Subject: AP1000 COL Standard Technical Report Submittal

APP-GW-GLN-009, Revision 0
Pressure Boundary Material Change
Technical Report Number 33

Document Number: APP-GW-GLN-009 **Revision Number:** 0
Title: Pressure Boundary Material Change

DCD Figure 5.3-2, Page 5.3-31

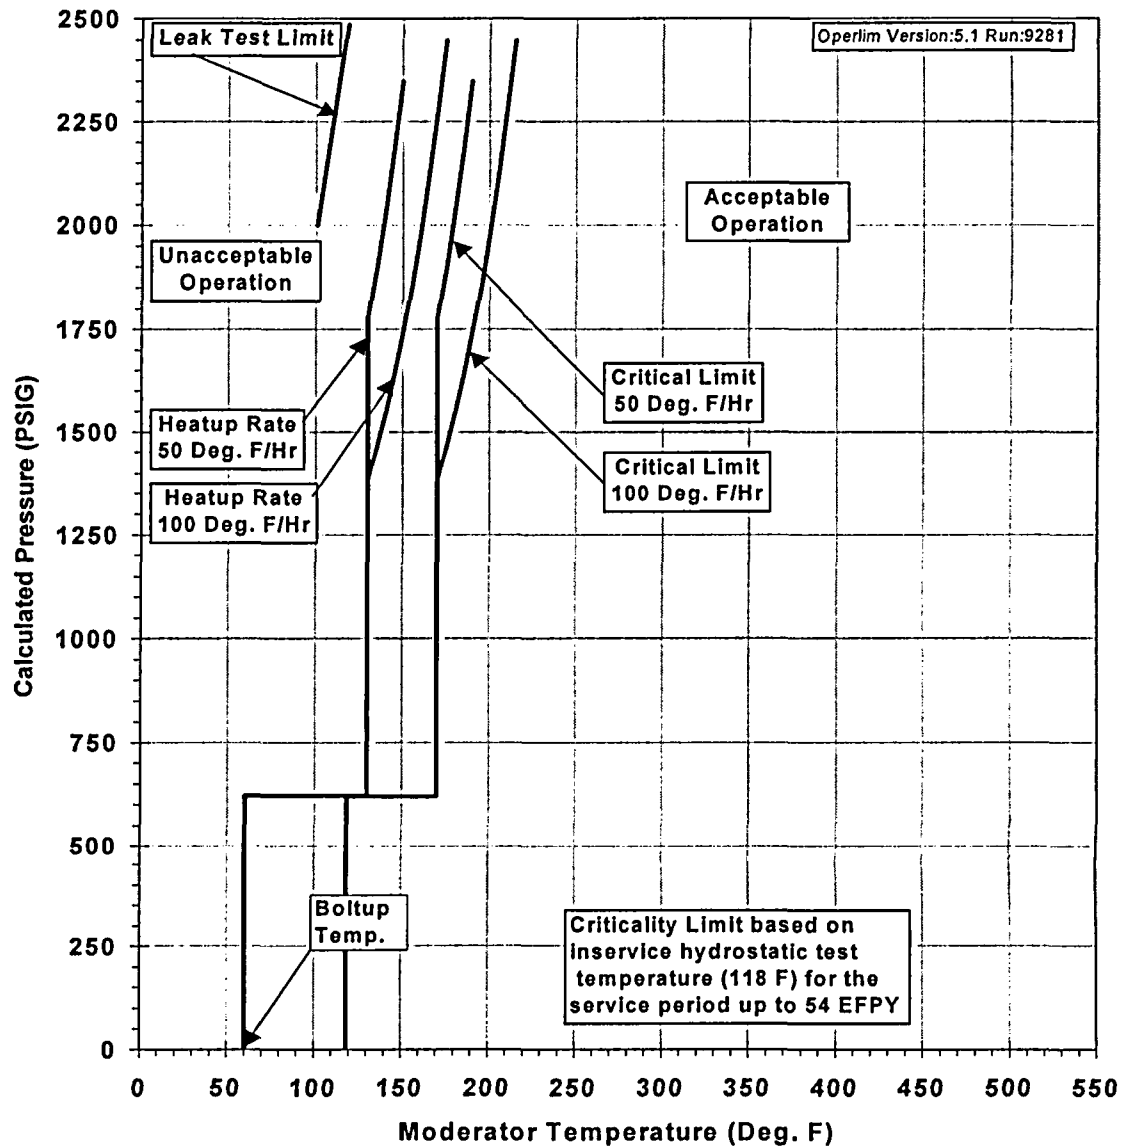
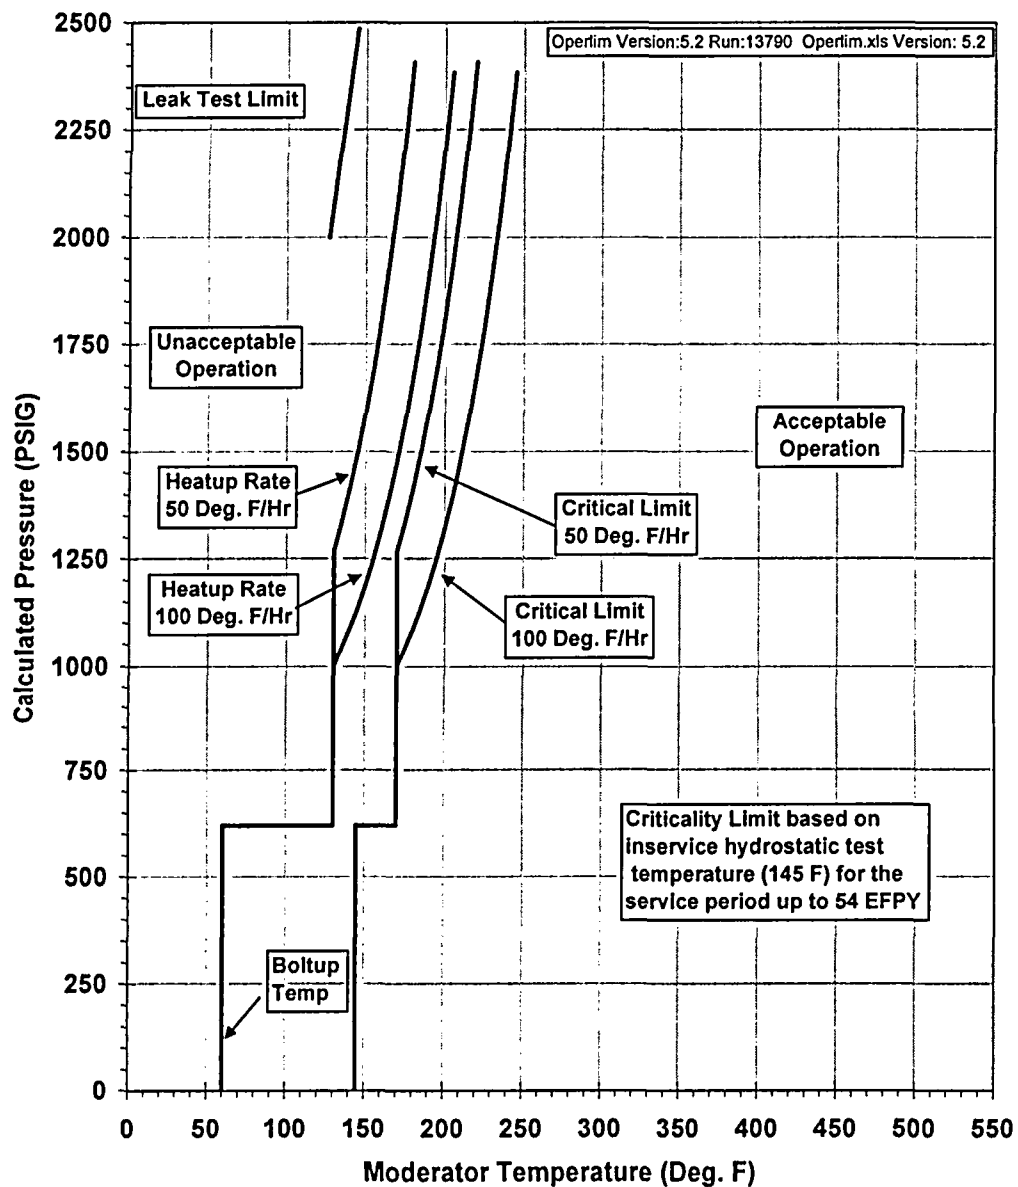
The impact of the higher copper limit on the pressure/temperature (P/T) curves is to slightly decrease the allowable operating range. However, this will not result in any significant restrictions on plant operations. See Section 5.0 for the comparisons between the current and proposed P/T curves. The LTOPS evaluation and the resulting parameters for the normal residual heat removal system relief valve are unaffected by the P/T curve changes since the lowest Appendix G limit has not changed.

In section 5.3.3.1, the maximum limit for the copper is stated as 0.03 wt %. The maximum copper content will need to be revised to 0.06 percent. The revised P/T curves resulting from the increase in copper content have been developed and are included as revisions to the generic curves provided in DCD Tier 2. The conclusion in subsection 5.3.3.3 that the P/T limits imposed on the RCS for operating and testing conditions are in conformance with the fracture toughness criteria of Appendix G to 10 CFR Part 50 is not impacted.

AP1000: 54 EFPY Curve, using 1996 App. G w/Kic, w/
flange, w/o margins; dated August 24, 2006
